# City of Richmond

## Report to Committee

**File:** RZ 21-940333

**Re:** Application by Gurjit Pooni for Rezoning at 8691 Heather Street from "Single Detached (RS1/B)" Zone to "Single Detached (RS2/K)" Zone

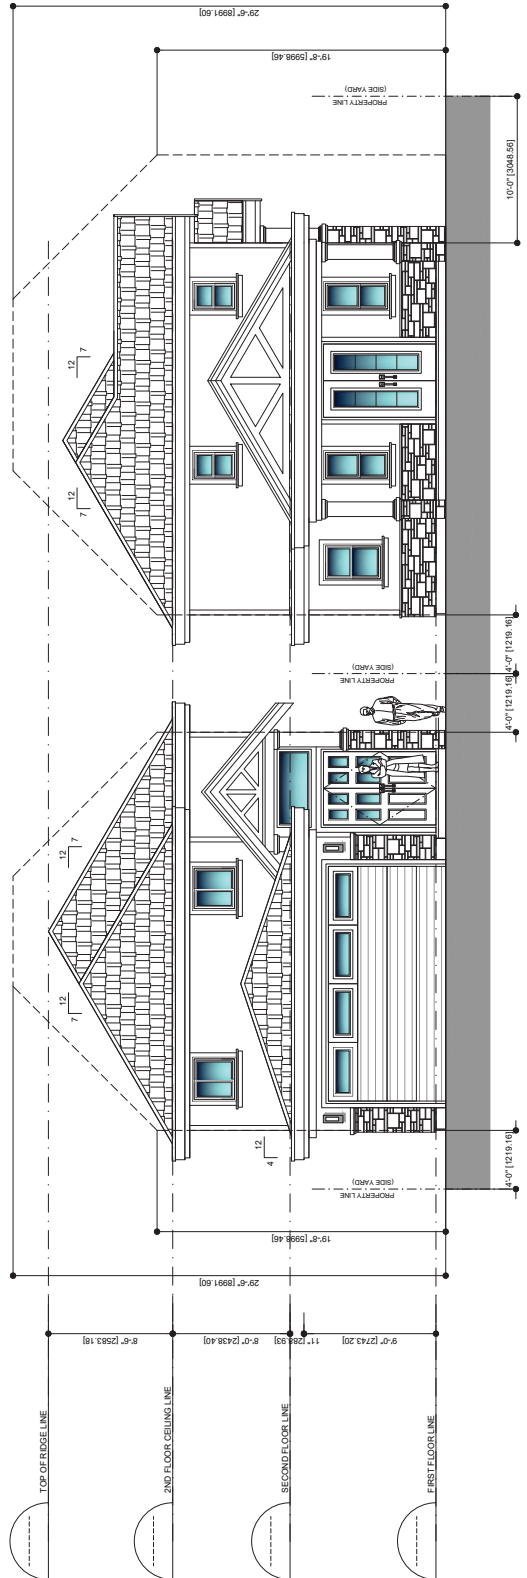
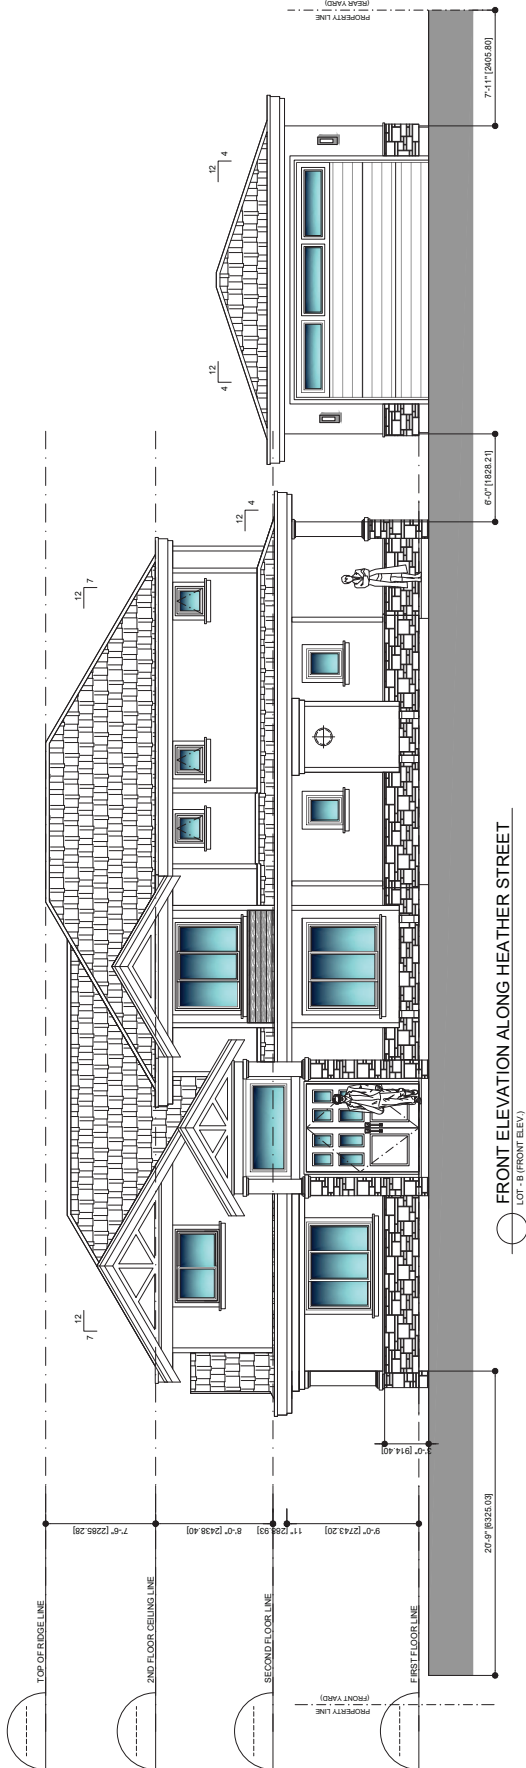
7. Registration of a legal agreement on title, ensuring that the Building Permit application and ensuing development of Lot B is generally consistent with submitted conceptual plans. Further design development of the east elevation is required prior to final adoption of the rezoning bylaw and to the satisfaction of the Director of Development to ensure the building presents an attractive pedestrian interface to Heather Street.

**Document Title:**  
Tree Management Plan rev2

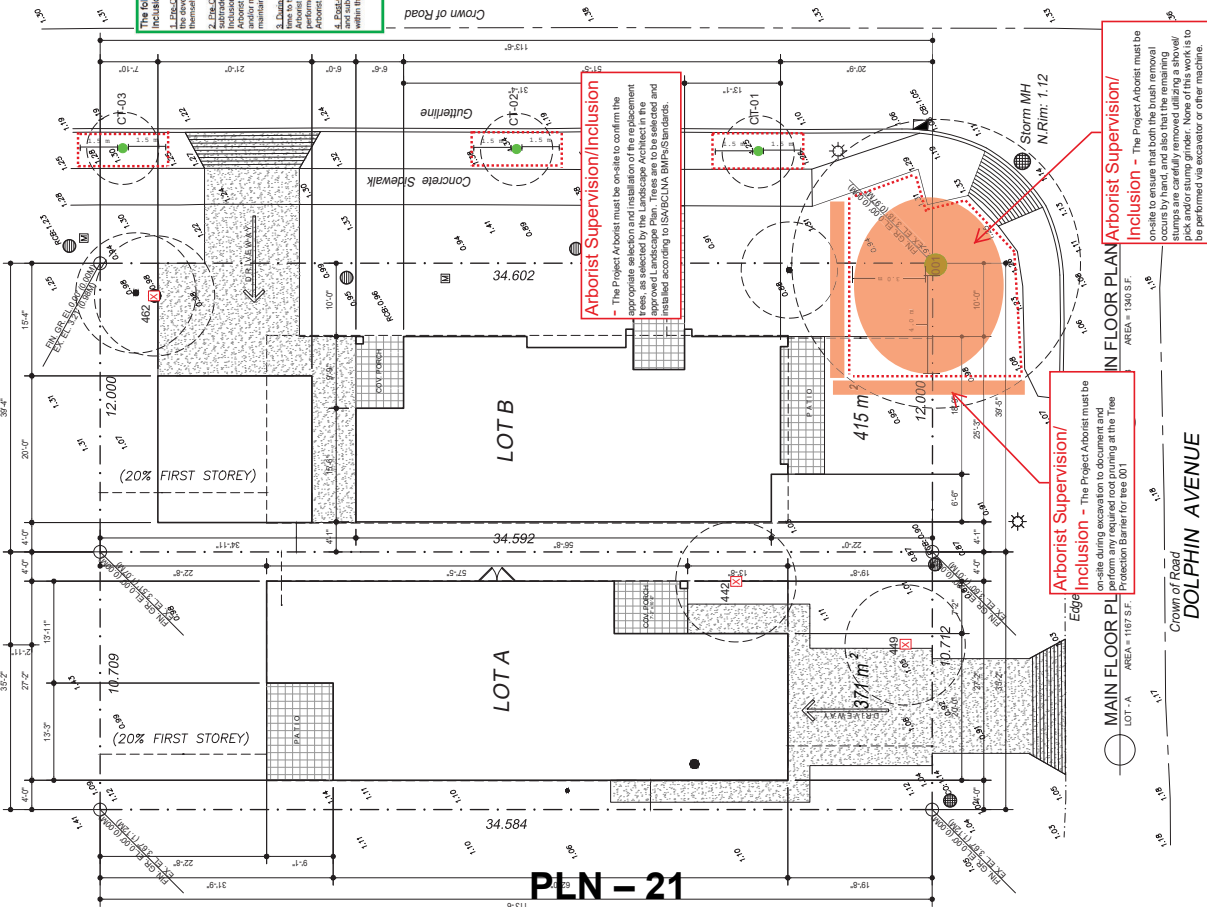
The City's Tree Preservation Coordinator has reviewed the Arborist's Report and supports the Arborist's findings, with the following comments:

- Three bylaw sized trees tag# 462 (Sawara cypress 21 cm caliper), tag# 442 (Western Red cedar, 21 cm caliper) and tag# 449 (Western Red cedar, 25 cm caliper) are identified as having poor shrub-like structure and of low retention value due to historical topping. These trees are recommended for removal with replacement at a 2:1 ratio.
- Four City trees tag# 001 (Shore/Lodgepole pine 62 cm caliper), tag# CT-1 (Hungarian oak 6-8 cm caliper), tag# CT-2 (Hungarian oak 6-8 cm caliper) and tag# CT-3 (Hungarian oak 6-8 cm caliper) are all identified in good condition and to be protected as per arborist report recommendations. A Tree Survival Security in the amount of \$25,000.00 is required for the City trees.

Four (4) trees (tag# 001, CT-1, CT-2, CT-3) on City property are to be retained and protected. The applicant has submitted a tree protection plan showing the trees to be retained and the measures taken to protect them during development stage (Attachment 6). To ensure that the trees identified for retention are protected at development stage, the applicant is required to complete the following items:

- Prior to final adoption of the rezoning bylaw, submission to the City of a \$25,000.00 Tree Survival Security for four (4) City trees (tag# 001, CT-1, CT-2, CT-3) to be retained.
- Prior to demolition of the existing dwelling on the subject site, installation of tree protection fencing around all trees to be retained. Tree protection fencing must be installed to City standard in accordance with the City's Tree Protection Information Bulletin Tree-03 prior to any works being conducted on-site, and remain in place until construction and landscaping on-site is completed.
